CITY OF LA VISTA
MAYOR AND CITY COUNCIL REPORT
JULY 5, 2011 AGENDA

Subject:	Type:	Submitted By:
CONDITIONAL USE PERMIT AMENDMENT – AUTOMOBILE DISPLAY, SALES, SERVICE AND REPAIR, LOT 16 SOUTHPORT EAST	◆RESOLUTION ORDINANCE RECEIVE/FILE	ANN BIRCH COMMUNITY DEVELOPMENT DIRECTOR

RECOMMENDATION REPORT

RE: Conditional Use Permit Application-Initial Review
Performance Auto-Lot 16, Southport East
Proposed Auto Sales in C-3 Zoning

PCSM
SITE PLAN

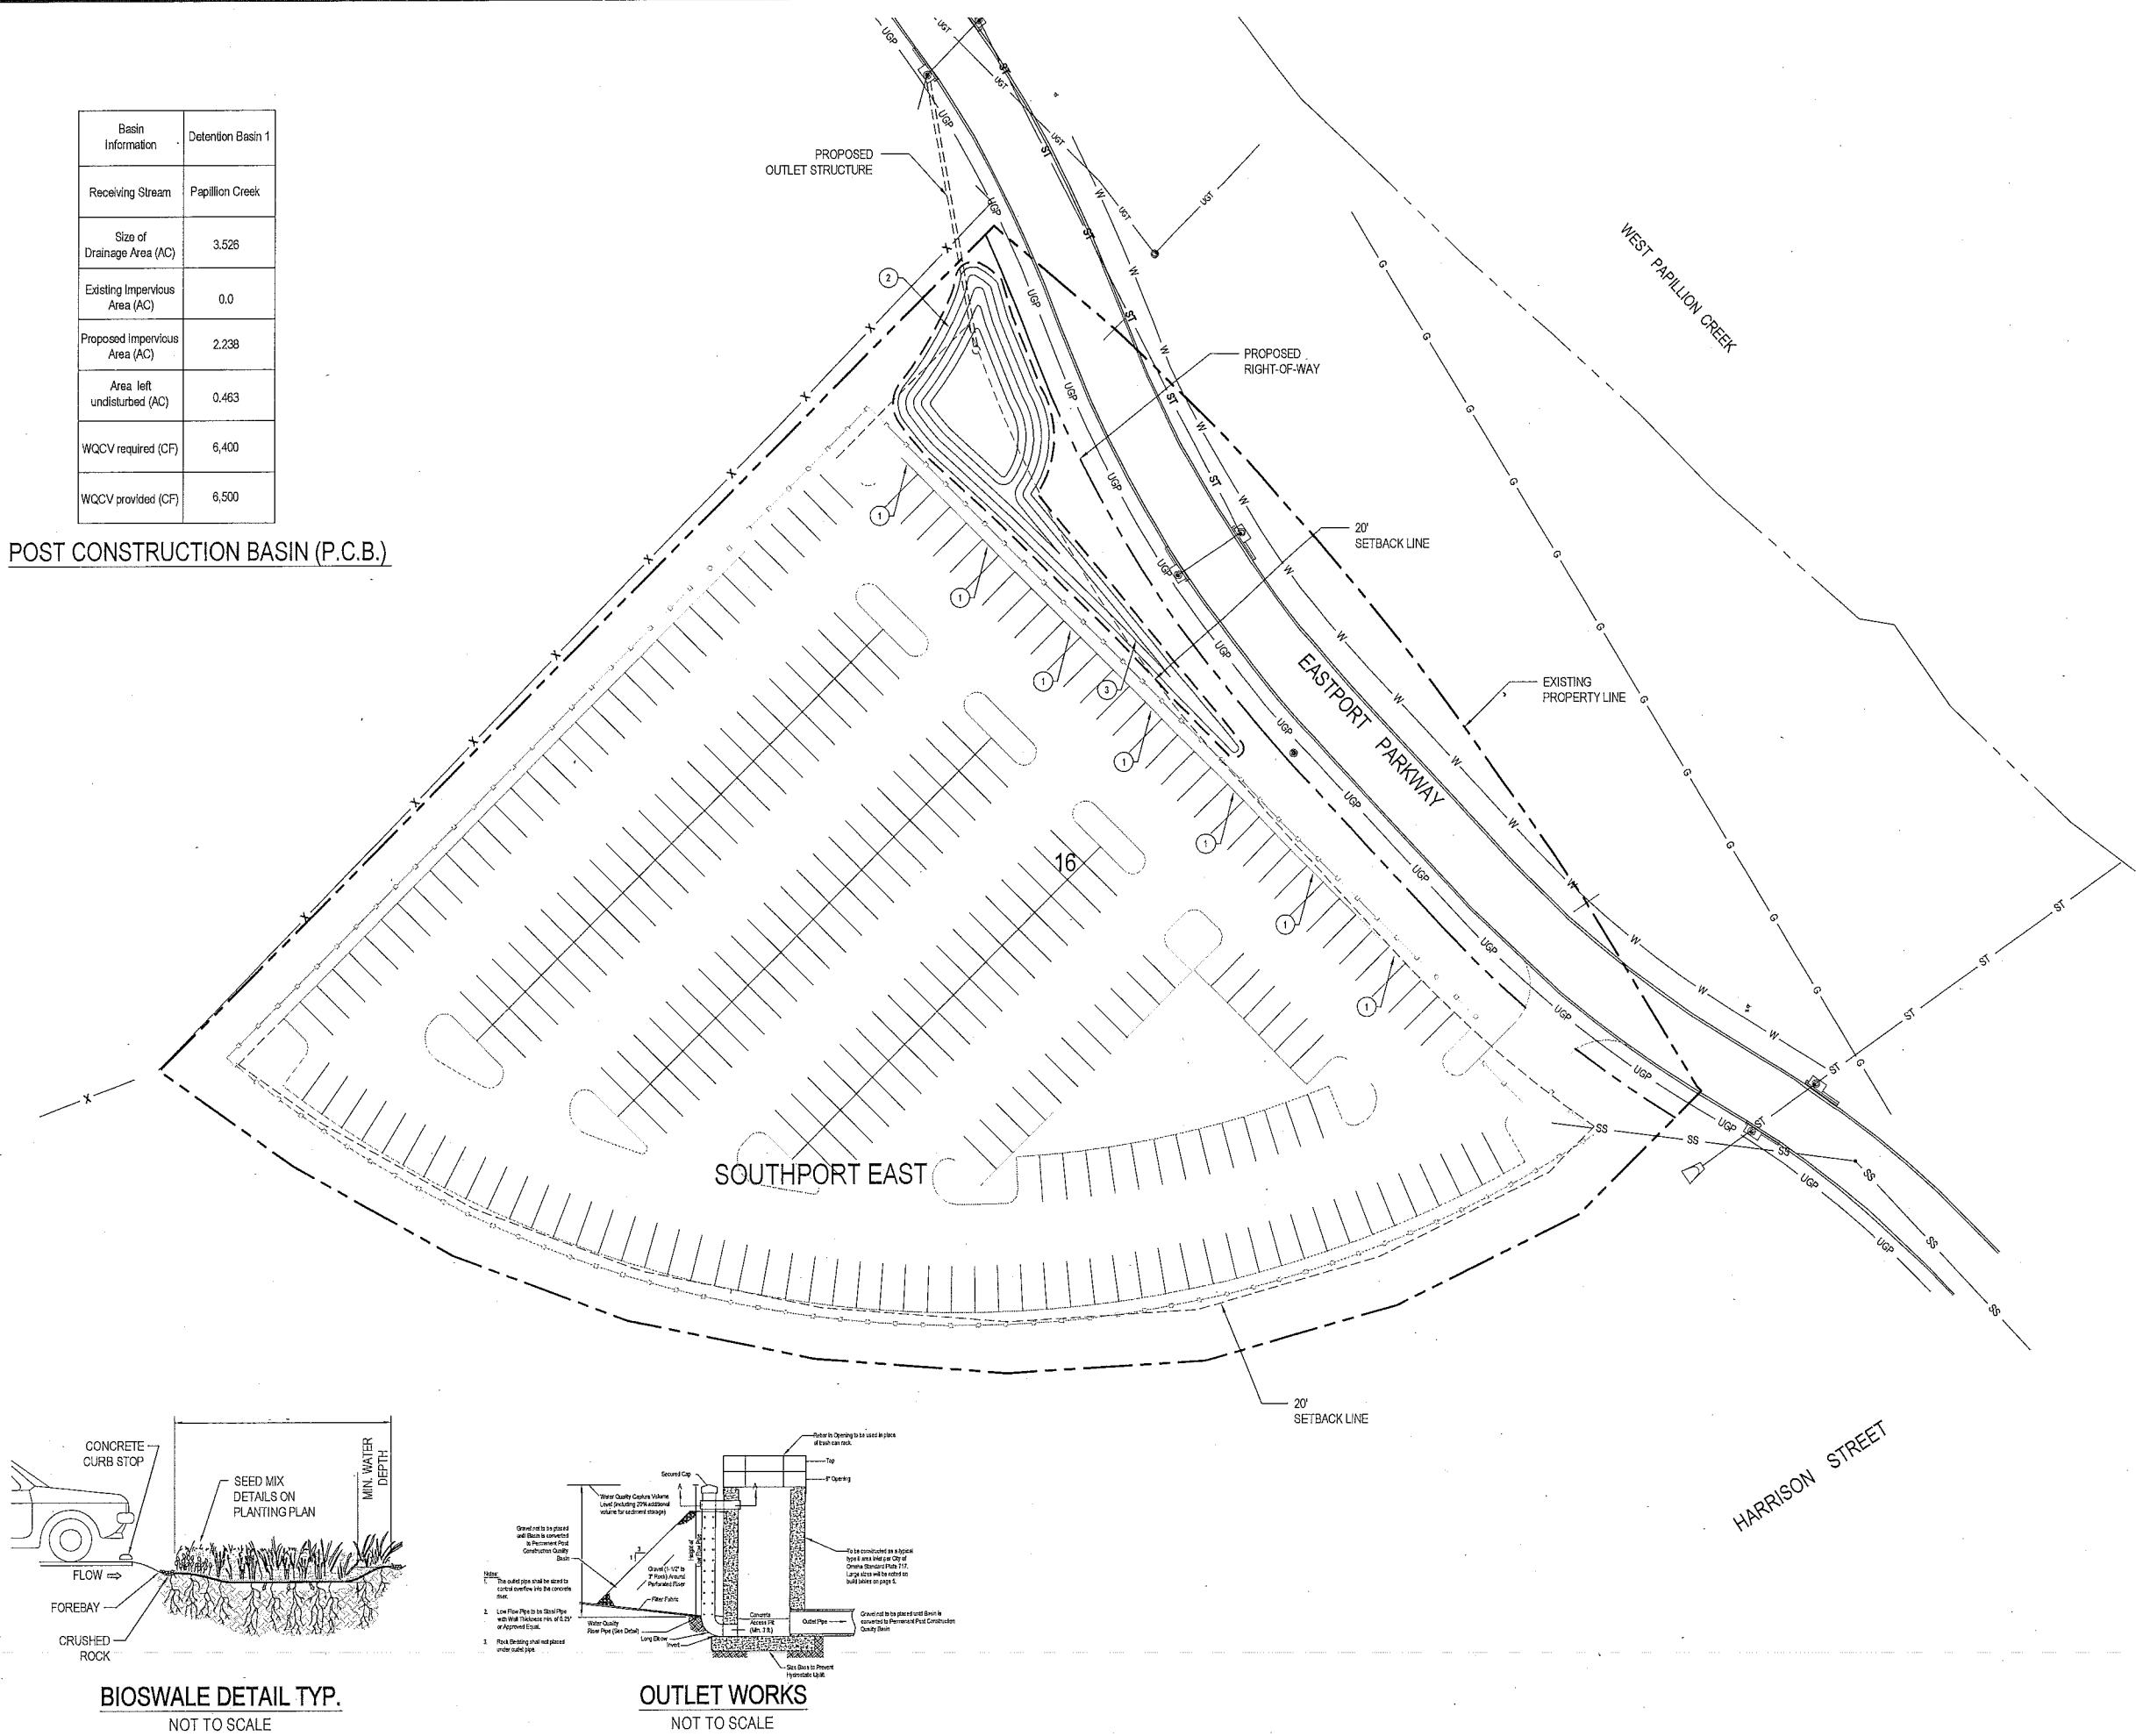
2. The applicant needs to prepare a conceptual Post Construction Storm Water Management Plan that provides for water quality treatment of the first-half inch of storm water runoff and provides for maintaining no increase in 2-year storm peak runoff flows above existing conditions. This is needed for compliance with the Papillion Creek Watershed Partnership policies. This should be submitted prior to Planning Commission consideration as it could impact the proposed site plan and the quantity of greenspace provided to meet the requirements.

Basin Information	Detention Basin 1
Receiving Stream	Papillion Creek
Size of Drainage Area (AC)	3.526
Existing Impervious Area (AC)	0.0
Proposed Impervious Area (AC)	2.238
Area left undisturbed (AC)	0.463
WQCV required (CF)	6,400
WQCV provided (CF)	6,500

CONDITIONAL USE PERMIT
SITE LIGHTING PLAN

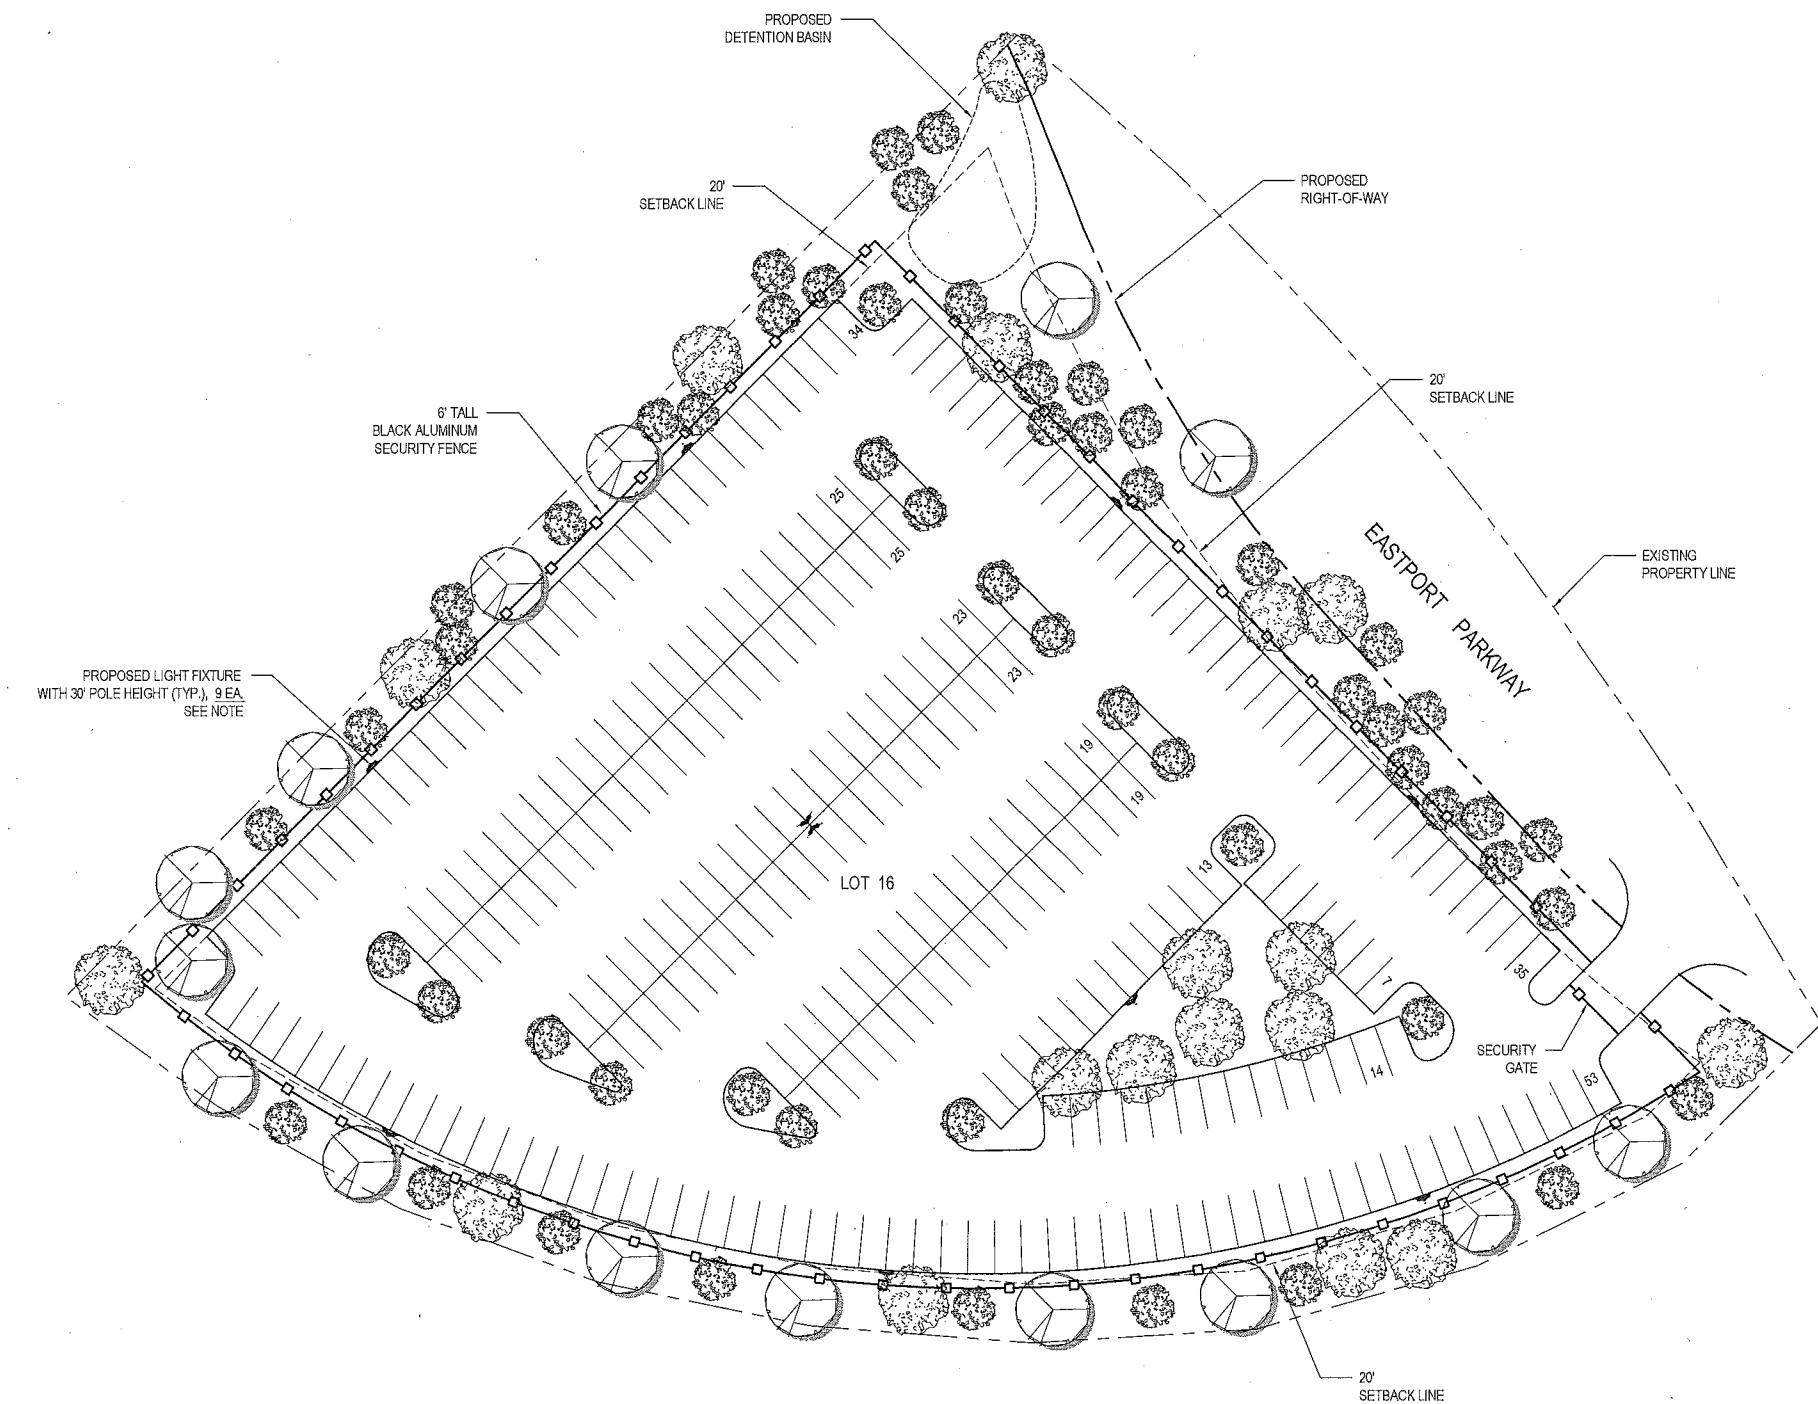
3. I recommend that a Site Electrical/Lighting Plan be part of the CUP. It appears that this type of plan was included in the prior CUP documents.
4. In regards to the text of the CUP document I have a couple of comments as follow:
